Haddam Neck Plant

Proposed Revision to Technical Specifications

Figures 3.4-1, 3.4-6, and 3.4-7  
Pages 3-5 and 3-6

June, 1985

Figure 3.4-1

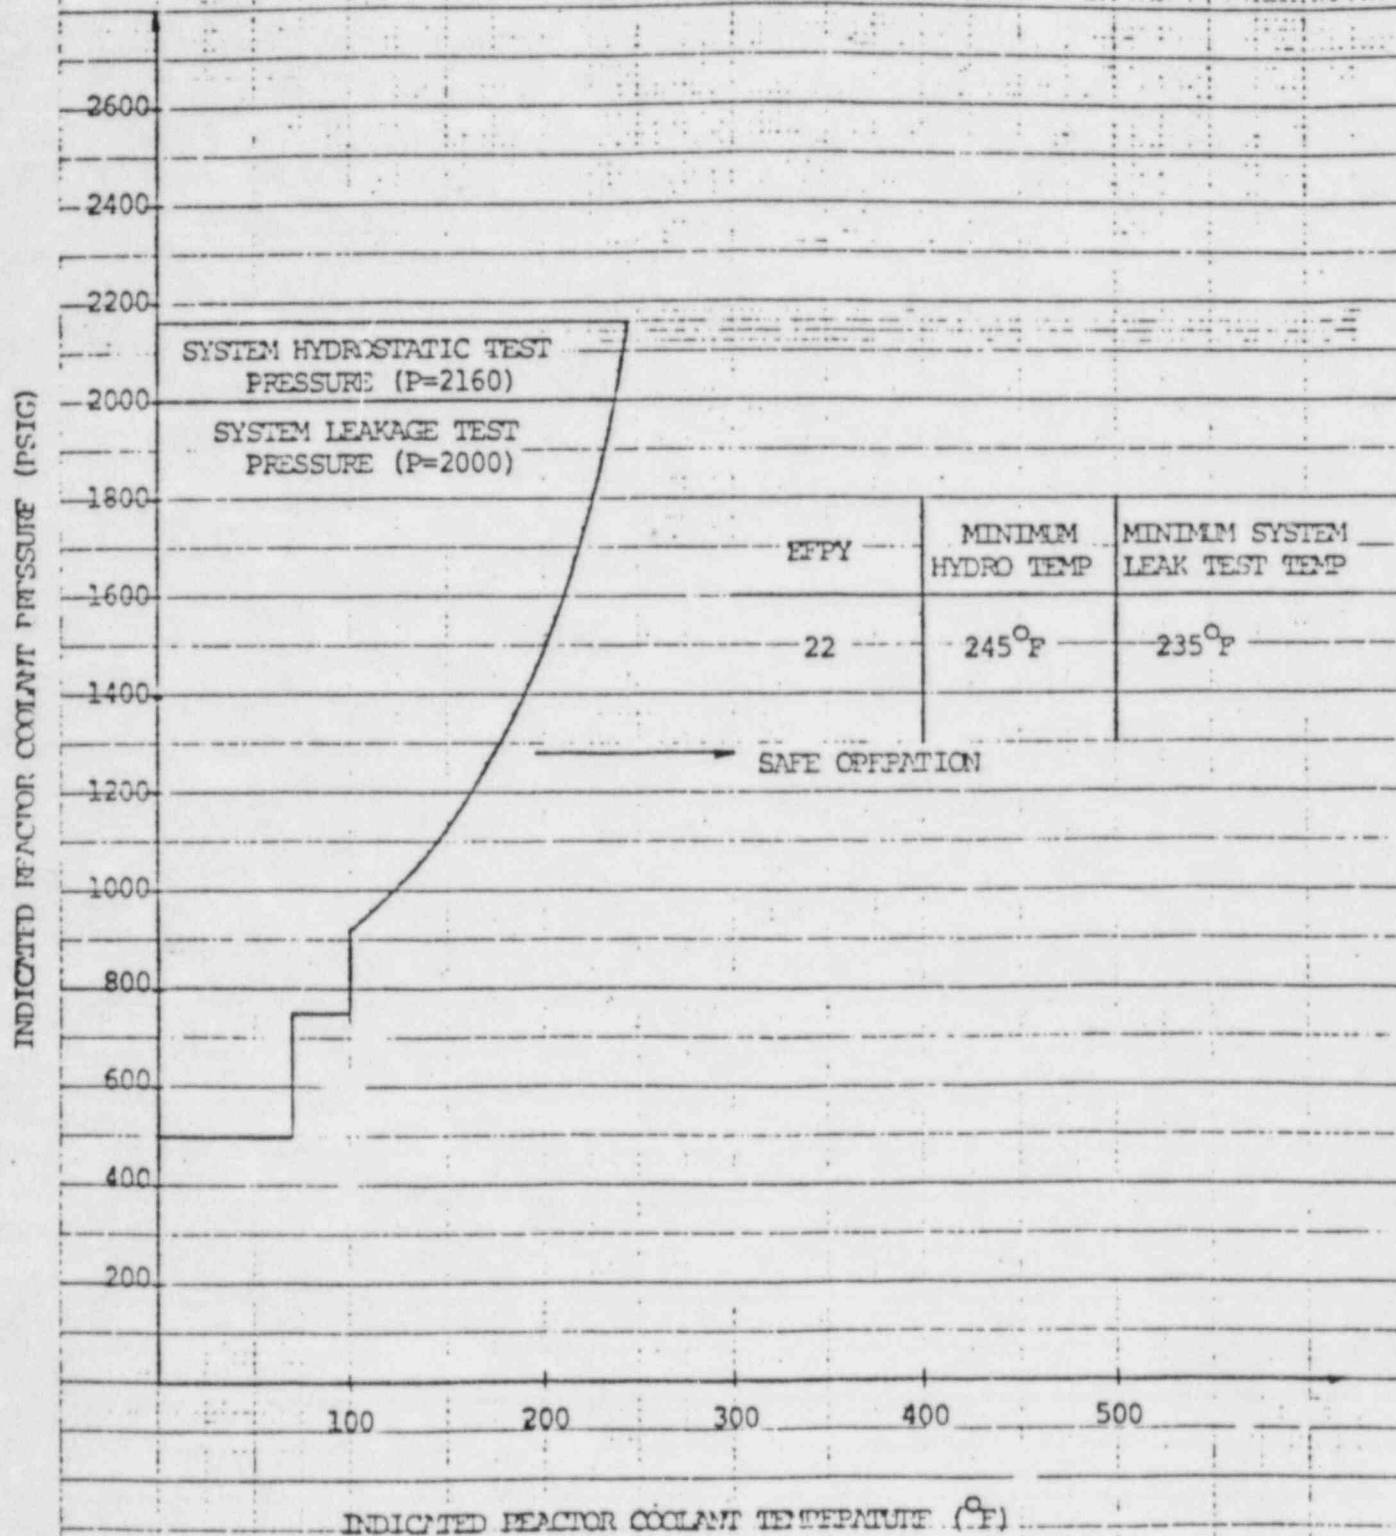
CONNECTICUT YANKEE LIMIT CURVE FOR HYDROSTATIC AND LEAK TESTING  
 APPLICABLE FOR 22.0 EFFECTIVE FULL POWER YEARS.

( $T_{\text{ERROR}} = 10^{\circ}\text{F}$ ,  $P_{\text{ERROR}} = 60 \text{ PSIG}$ )

Figure 3.4-8

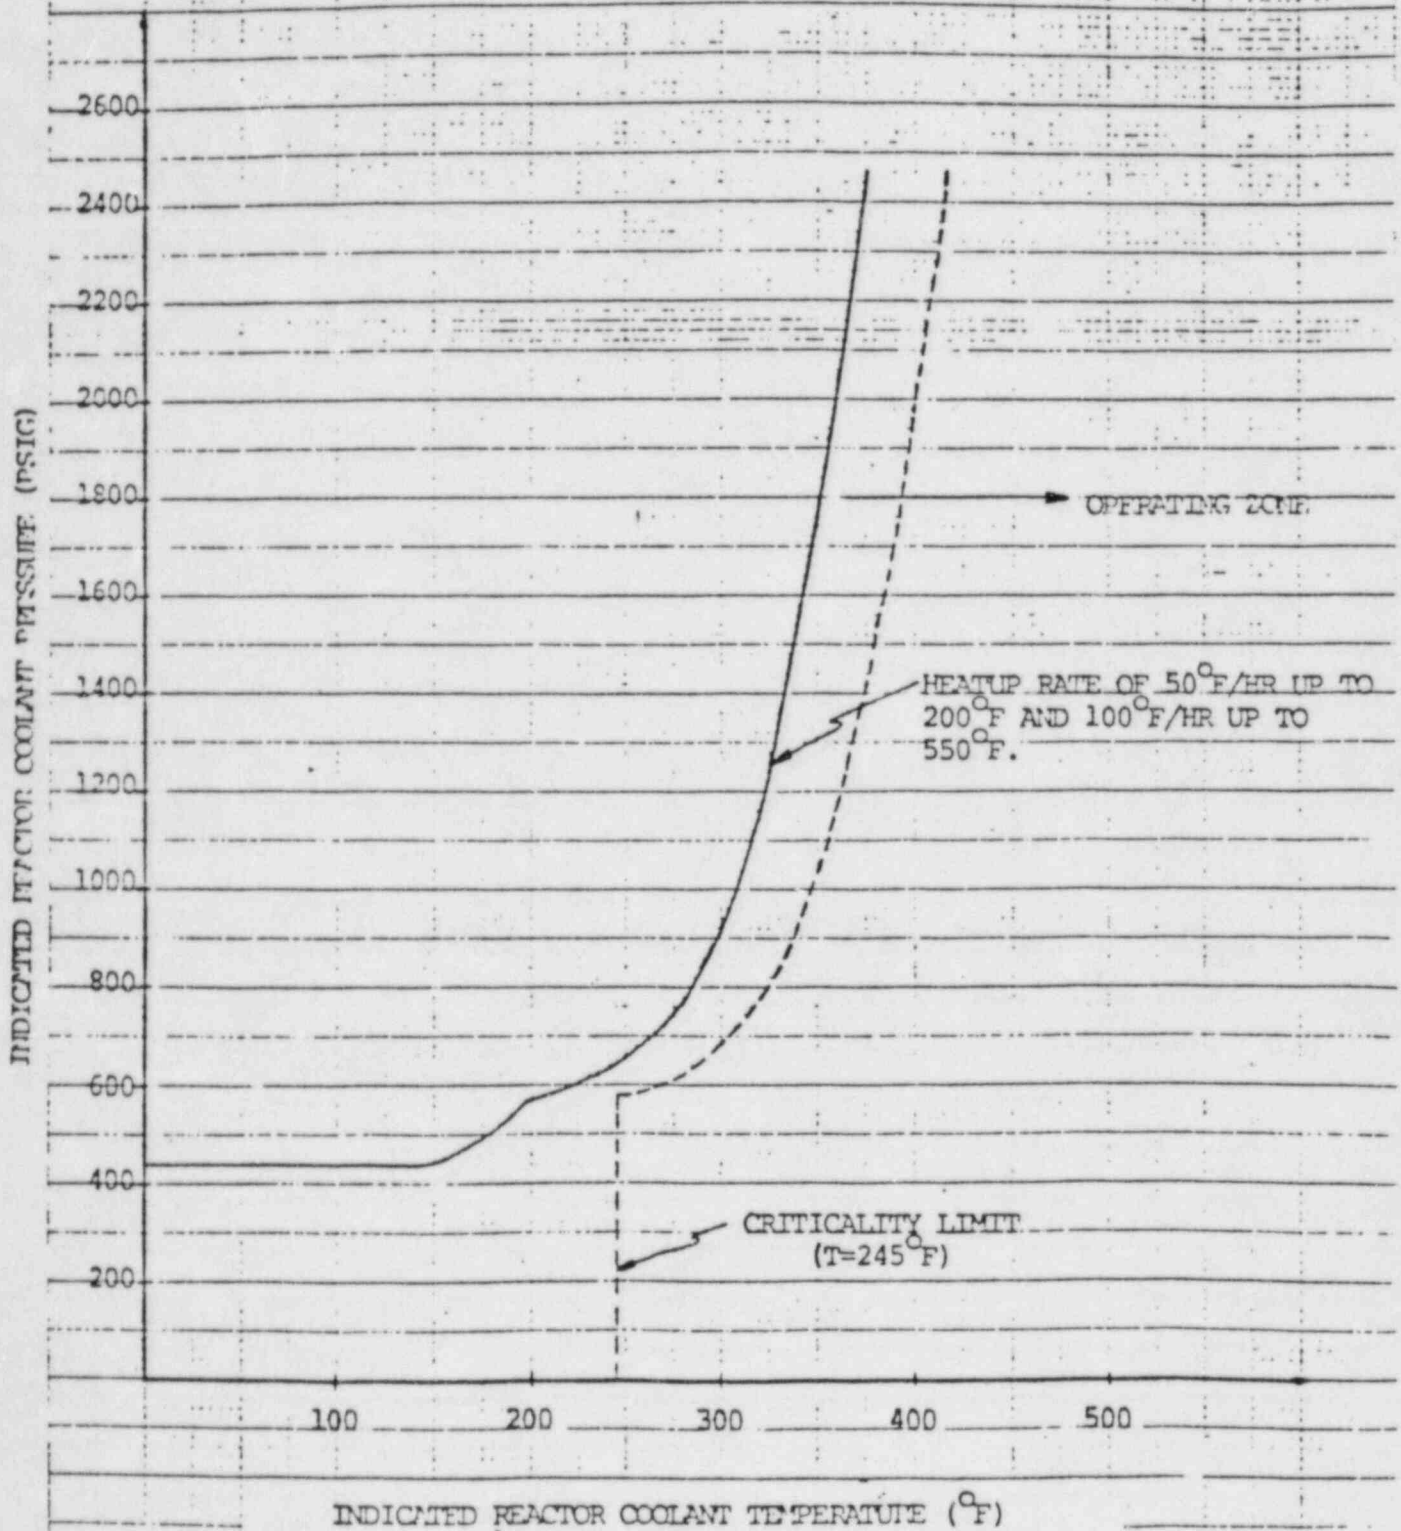
CONNECTICUT YANKEE REACTOR COOLANT SYSTEM HEATUP  
LIMITATIONS FOR 22.0 EFFECTIVE FULL POWER YEARS.

( $T_{\text{ERROR}} = 10^{\circ}\text{F}$ ,  $P_{\text{ERROR}} = 60 \text{ PSIG}$ )

Figure 3.4-9

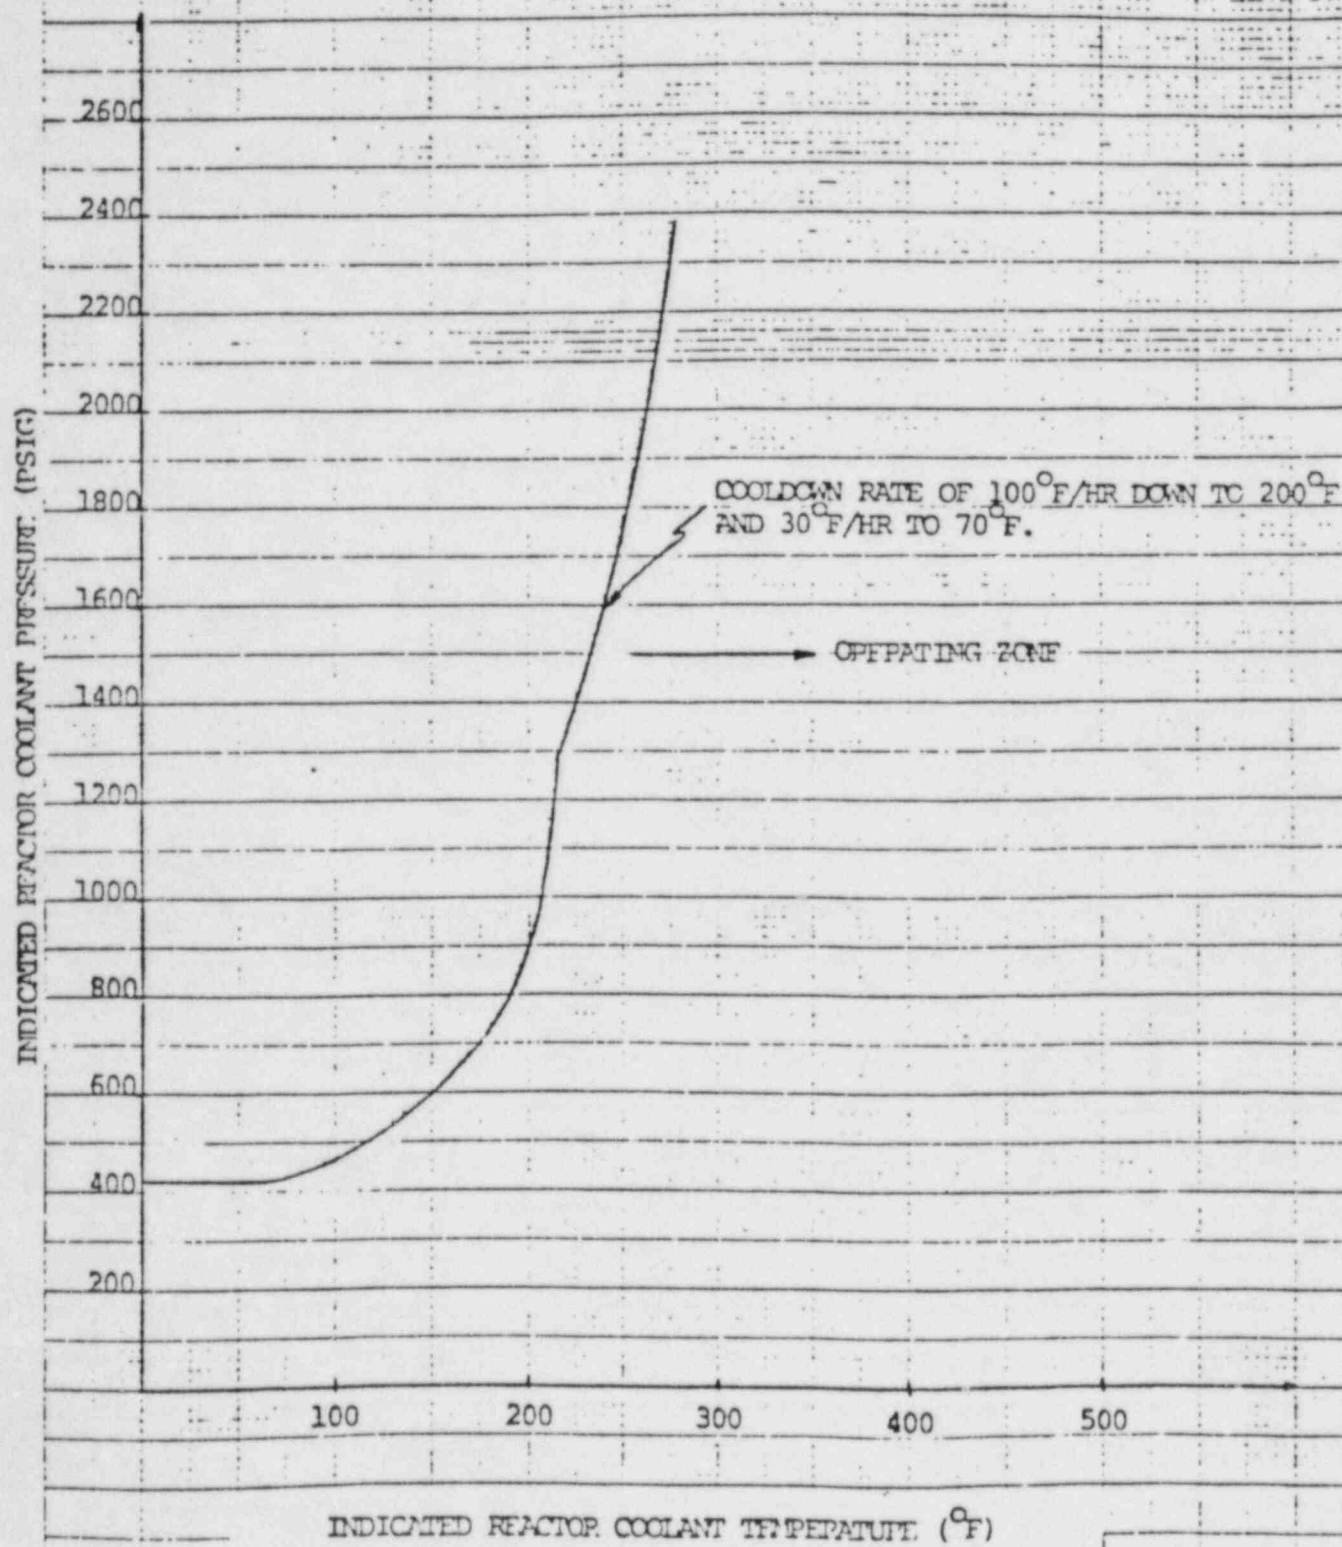
CONNECTICUT YANKEE REACTOR COOLANT SYSTEM COOLDOWN  
LIMITATIONS FOR 22.0 EFFECTIVE FULL POWER YEARS.

( $T_{\text{ERROR}} = 10^{\circ}\text{F}$ ,  $P_{\text{ERROR}} = 60 \text{ PSIG}$ )
